Technical Service BULLETIN

ACCESSORY DRIVE BELT/ BELT TENSIONER ASSEMBLY NOISE

'03 - '07 Corolla & Matrix

ENGINE
EG021-07

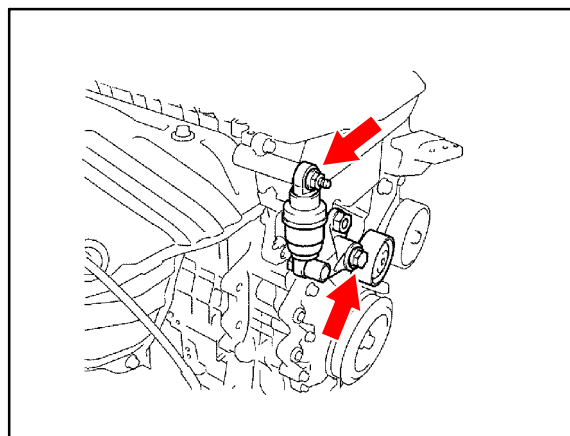
4. Remove and replace the belt tensioner assembly.

Install a NEW drive belt tensioner assembly with the bolt and nut.

Torque:

Bolt: 69 N•m (704 kgf•cm, 51 ft•lbf)

Nut: 29 N•m (296 kgf•cm, 21 ft•lbf)
